Rugby Model Engineering Society Ltd

Safety Management Manual

APPENDIX 1: Safety Concern Register

02/2016

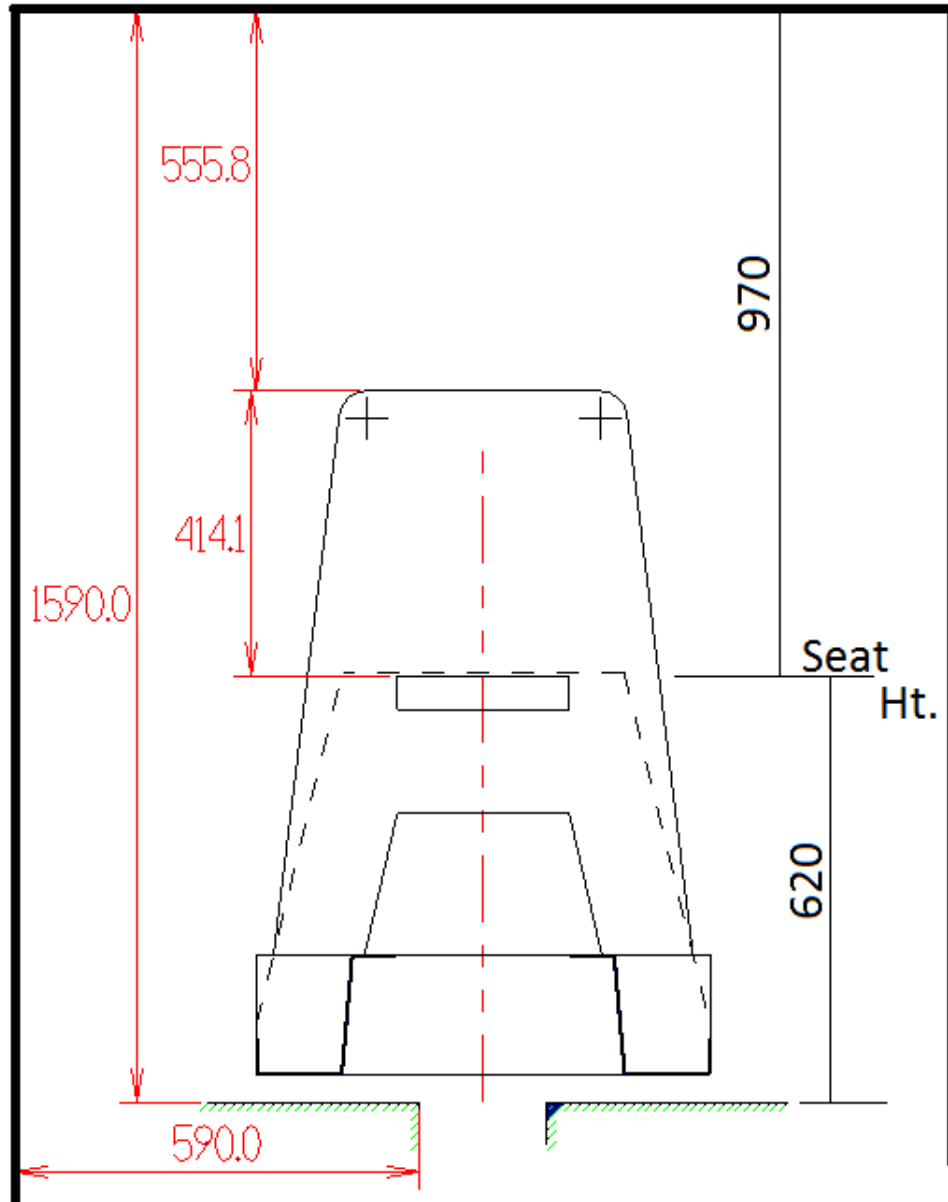
Raised seat for Guard is too high. Likelihood of Guard striking head on over-bridge. Drawings have shown that a 5'9" tall Guard (me) will have 2" clearance or less when passing under the bridges. We have several members who are taller than me, as the height increases then this clearance figure reduces. Likelihood of a strike is very high, result of it will be severe head injury possibly resulting in death.

Raised backrest for Guard is too high. Solid plywood backrest is far taller than required. By having a tall solid backrest, if this vehicle is marshalled in the middle of a train, the Guard will have severely restricted viewing of a number of passengers in the seat in front. Any child up to the age of about 5 would be able to sit against this backrest and would not be seen by the Guard of the train. They could even sit round sideways and stand up before they were seen by an observant Guard. Additionally, given the raised seat and the danger that presents as already pointed (con't)

Remove the raised seat. Reduce the seat height back down to that of the rest of the coach. This will give a clearance of around 8" to a 5'9" Guard. Likelihood of striking head is very much reduced.

Remove the tall fixed backrest. Replace with a drop in backrest as per the 100 Series coach so it can be removed in the event of the carriage being marshalled in the middle of a train (con't)

out, the likelihood of injury by bridge strike is further increased as the tall backrest would serve to pin the unfortunate Guard in his position.

when train requirements force the use of more than one fixed set of coaches, or reduce the height so it matches the front and standard end plates. We can't afford the space to have dedicated coaches that can only be used by certain people on certain trains in certain positions.

The design as referenced by this safety concern will not go ahead. An alternative design as presented by our Chairman will be used for guard's carriages. The alternative design was agreed by the meeting on 24 February 2016 and will remove all of the concerns raised by 02/2016 and 03/2016.
